CODE MODIFICATION REQUEST
(COMMERCIAL)

BUILDING/STRUCTURE NAME: Lee's Summit Downtown Market Green Street

PREMISE ADDRESS: 220 SE Green Street, Lee's Summit, MO 64063

RESUBMITTAL UPDATE REQUEST: After the initial submittal request, City Staff comments were to make the sidewalk ramp an interactive part of the playground. And to make it obvious that it is not an ADA path. We are attaching an additional document depicting surfacing the walkway with an anti-slip acrylic product, similar to what is used on tennis courts, and then painting sidewalk games onto the surface. We are also proposing attaching interactive play accessories onto the wall of the City Hall building, locating so that they don't obstruct existing windows, and that they are mounted at a height inclusive to all users and abilities. We will be removing the hand railing that is on the building. We are showing a surface graphic at both ends of this walk that announce the playground in a playful way vs using a regulatory sign stating that this walk is not ADA. The graphics and wall hangings are still conceptual in this drawing and the final selections and locations will be made after this request is ultimately approved.

1 LAYOUT KEY PLAN

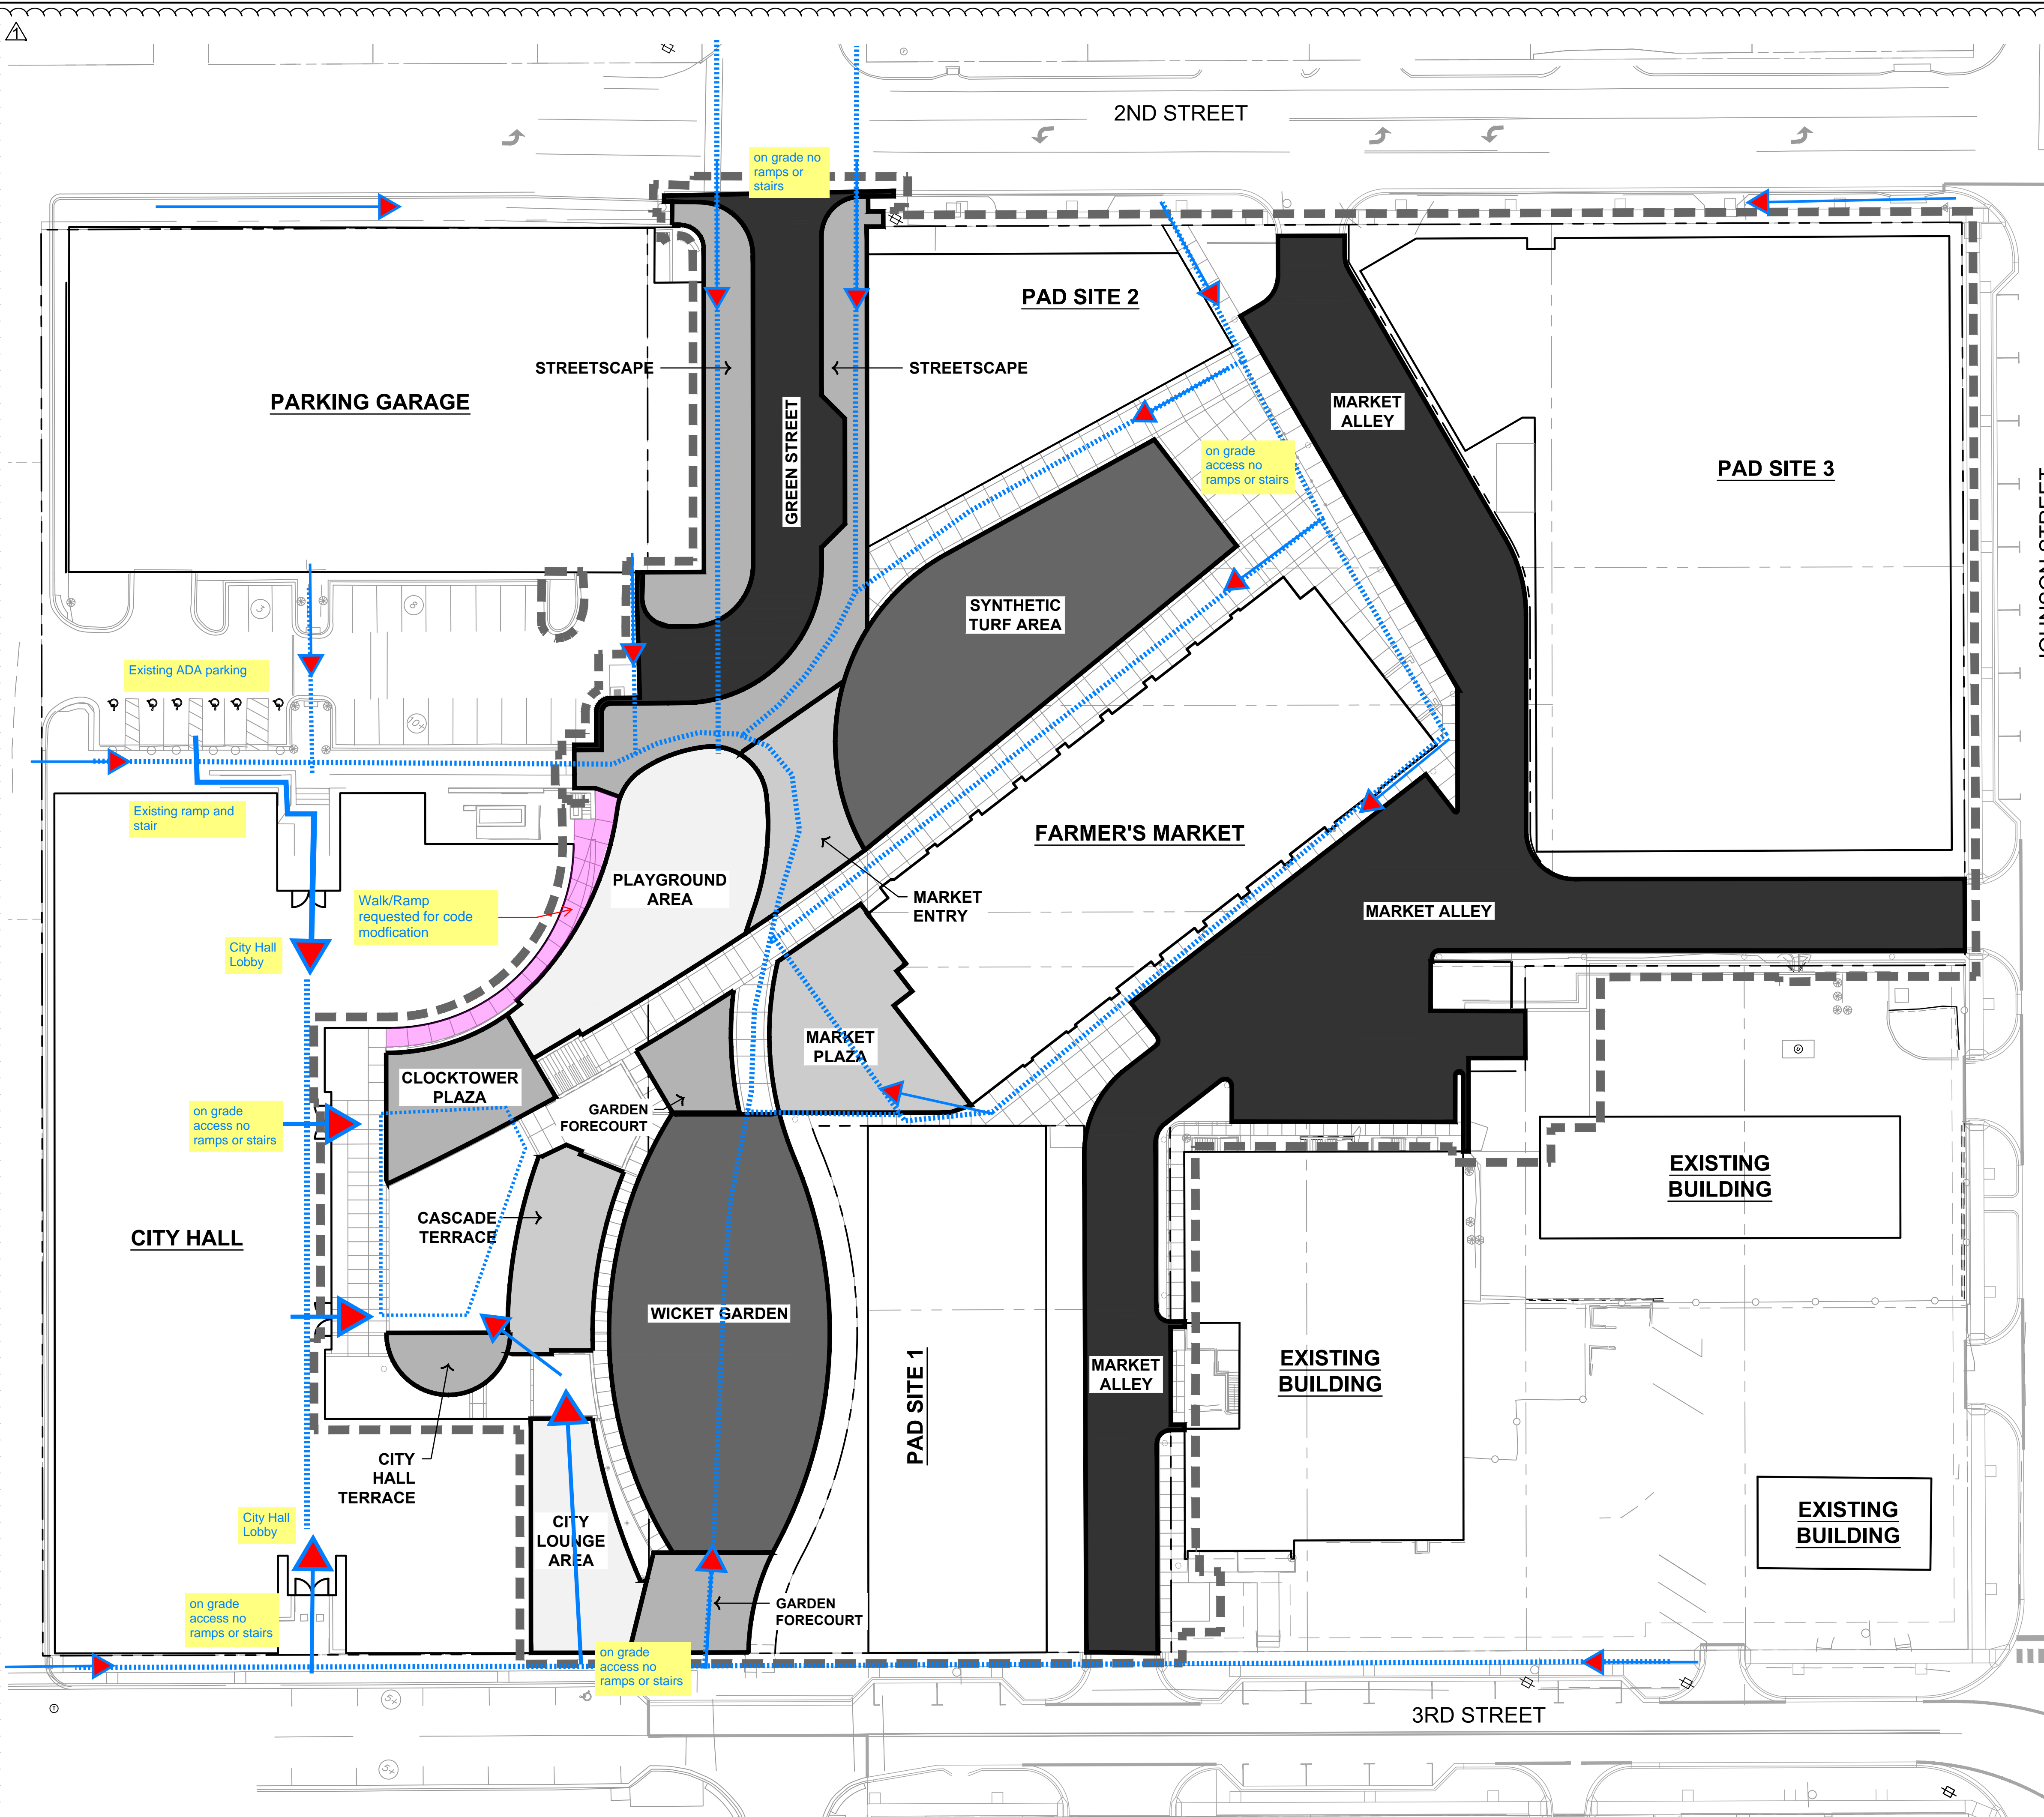
North ramp requires handrails on both sides of ramp. Existing handrail is non-compliant in height, extensions and 1.5" min clearance (Playground Ramp)

CMR-.8 to allow for approval of eliminating the handrail on both sides of the sidewalk ramp adjacent to the playground;

Playground Ramp

1. Remove the handrail from building.
2. Integrate the walkway so that it is part of the play experience. Suggestions were to apply games like hopscotch, four square, etc to the walk surface using acrylic paint.
3. Make the walkway interactive by attaching accessories to the building façade that can also be used for play or other sensory experiences. Coordinate with the windows so as not to block them.
4. Provide a solution at each end of the walk that makes it more obvious that this is not an ADA pathway but instead an entrance into the playground.

Remove all railing from building along this path
